Review of "A simple approach to represent precipitation-derived freshwater fluxes into nearshore ocean models: an FVCOM4.1 case study" by Rutherford et al.

Reviewer comments in black; Responses in blue.

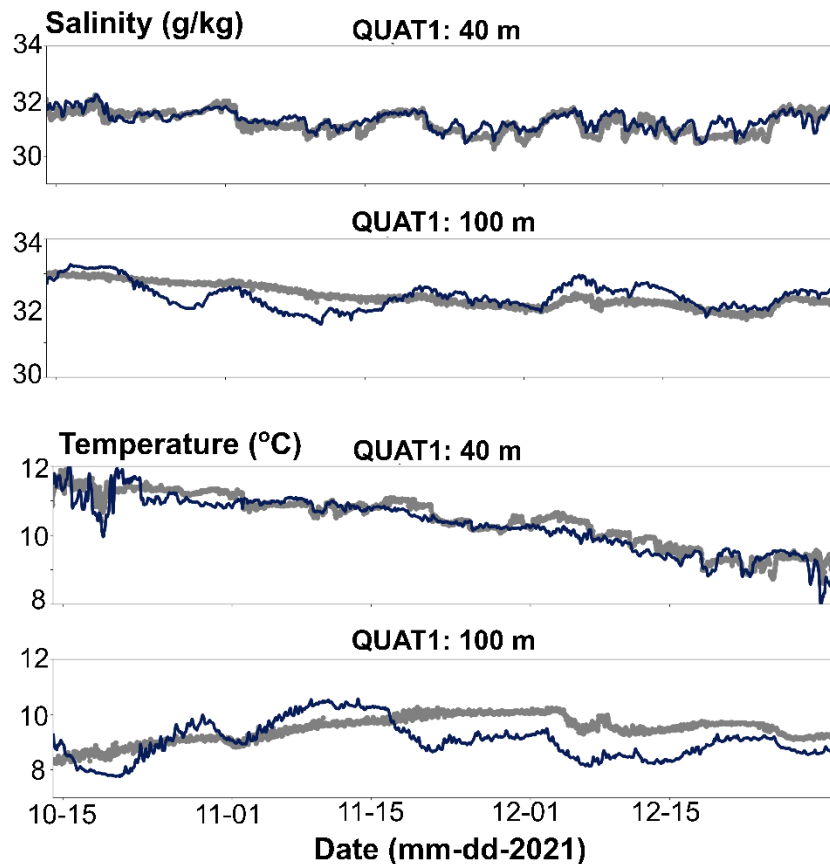
- Insufficient time was dedicated to validating the CIOPS-W model in the region under study. This raises concerns about whether the CIOPS-W model itself could be a source of errors from the initial states and the boundary conditions used in their coastal circulation model.

We found that the Quatsino Sound model performs well at the outer mooring (QUAT1; Figure A4a in manuscript), which experiences the effects from both CIOPS-W's initial and open boundary conditions. To illustrate this point, we show comparisons of the model to temperature and salinity data from QUAT1 at two depths (40 and 100 m; Figure R2.1 below). The model also performs well at QUAT2, which is farther in the inlet

and consequently only sees effects of CIOPS-W open boundary conditions (initial conditions here are based on CTD observations). We thus feel confident that CIOPS-W provides appropriate initial and boundary conditions on the shelf for the present study. That said, the current manuscript focuses on the upper 50 m of the water column inside the Sound, where the role of the open boundaries is minimal due to the typical estuarine circulation. Therefore, we do not plan to add extra material in this study to provide confidence into CIOPS-W-based initial and boundary conditions; however, we will make use of this useful comment and address this topic in our next manuscript.

Figure A6: Histograms of (a,b) salinity (g/kg) and (c,d) temperature (°C) for the model (green) and observations (yellow) for the entire water column. The left panels show histograms for the entire model domain whereas the right panels show histograms for the model domain excluding Neroutsos Inlet.

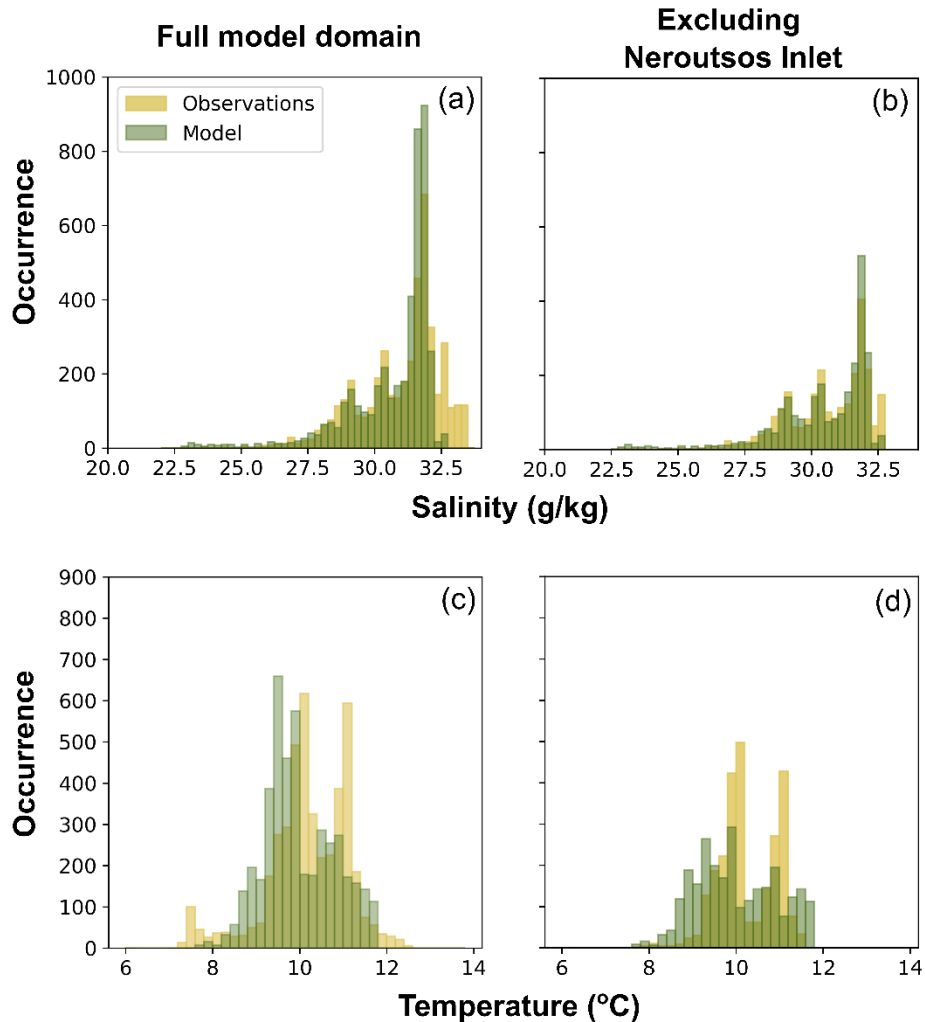
- Validation of the properties of deeper water should be considered. While the 0-50m depth is directly affected by river flow, this could also influence the content of deeper water through estuarine circulation.

While we agree in principle with this comment, we think that adding detailed validation of the full water column to the present manuscript will make it too long and is slightly out of scope given the focus on the top 50 m (i.e., the region where freshwater will have the largest impact). We intend to include a more detailed, whole-column validation in an upcoming manuscript that will focus on all depths in the modelled region. We thus propose adding the figure and text below to the appendix as a brief evaluation of the model's performance for the whole water column.

Appendix A5 CTD profiles: Full Water Column Evaluation

Additional evaluation of modelled salinity and temperature against CTD profiles spanning the full water column showed reasonable agreement (Figure A6). The distribution of modelled salinity agrees well with the CTD observations (Figure A6a), particularly if we exclude Neroutsos Inlet from the analysis (Figure A6b). As discussed, the model shows over-mixed conditions in this deep and narrow inlet (see more details in lines 307-313). Modelled temperature adequately compares to CTD temperature observations throughout the entire water column (Figure A6c), with a similar comparison as in the top 50 m (Figure A3a). More specifically, the model has a smaller temperature range than the observations, unable to capture the cooler (<

8°C) and warmer (>12°C) temperatures, in large part due to the issues encountered in Neroutsos Inlets (Figure A6d). Future work will perform a more rigorous evaluation of the full water column.

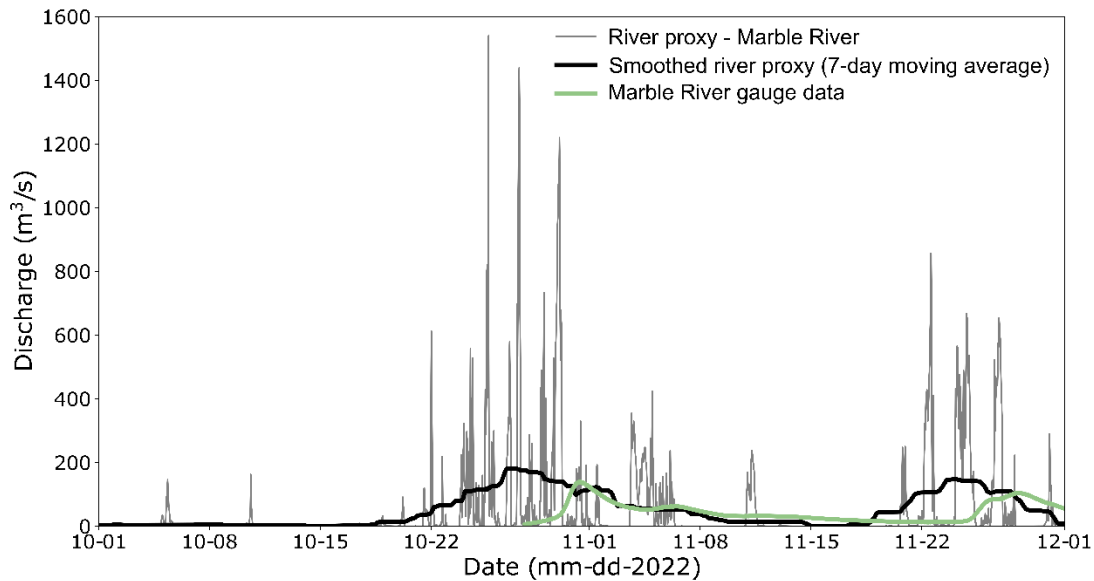
- A comparison with the Marble River at a higher time resolution than monthly could provide more detailed insights (line 196). One suggestion could be to combine Figures 4 and 5 for this purpose.

Rather than merging Figures 4 and 5, we will add a new figure in the appendix to provide further visuals to compare the proxy to the Marble River gauge data at higher resolutions. As we mention at line 345, the assumptions in this method produce at times large spikes or pulses in river discharge, most notably for the Marble River (seen in Figure 4). These spikes are unrealistic when compared to hourly discharge time series from most large rivers, which are typically much smoother. That said, the proxy is able to represent the magnitude of the discharge on longer timescales, for example monthly, as seen in Figure 5, and weekly, as it will be shown in the new Appendix B figure below.

“Despite these limitations, the simplicity and ease of application of the method make it worthy of analysis, as it could provide some information on river and stream outflows that may otherwise be unavailable to and thus ignored by coastal ocean modellers. To illustrate the proxy’s ability to estimate river discharge, we evaluated the performance of these methods for the Marble River; the river proxy was applied to the available HRDPS-1km precipitation time series (2021-2022) for comparison against the available discharge data, which has only been collected since October 2022. Although these time periods have minimal overlap (~ 2 months), the available data can inform the proxy’s ability to estimate river discharge. For instance, the monthly mean river discharge estimated by the river proxy is comparable to the monthly mean discharge measured by the Marble River gauge (Figure 5). Notably, the 2021 river proxy values for September to November were higher than values for the same period in 2022 calculated from both the proxy and from the river gauge. Considering that fall 2021 was a particularly rainy year that included an atmospheric river in mid-November, these values are reasonable. **Furthermore, while the half-hourly proxy dataset shows large spikes, a 7-day running mean suggests that the method produces an appropriate amount of river discharge at**

weekly timescales (Figure B1). Overall, these comparisons illustrated the proxy's ability to reasonably represent the freshwater discharge at weekly and longer scales.

To further illustrate the ability of the rain-based proxy to provide reasonable amounts of fresh water to the Quatsino Sound fjord system, we show comparisons of the proxy (applied to the Marble River watershed), its 7-day running mean, and the Marble River gauge data for October and November 2022 (Figure B1). The proxy and gauge data only overlap for this short period at the end of 2022. While the proxy time series (grey; datapoints every 30 minutes) shows large spikes due to its assumptions and limitations (see Section 3.3.3), the 7-day running mean of the proxy (black) produces more realistic values in alignment with the data from the Marble River gauge (light green). While the magnitude of the smoothed proxy is similar to the Marble River gauge data, the limitations of the methodology (e.g., no storage of rain in soil or lakes) are still evident. For instance, the 7-day running mean of the proxy produces river discharge that peaks earlier than the gauge data during rain events (e.g. November 20-30th). Additionally, the smoothed proxy time series reaches a minimum value of 0 m³/s in between rain events whereas the gauge data does not (see around November 15th). Despite these differences, the proxy is able to deliver adequate amounts of fresh water to the system over a 7-day period.
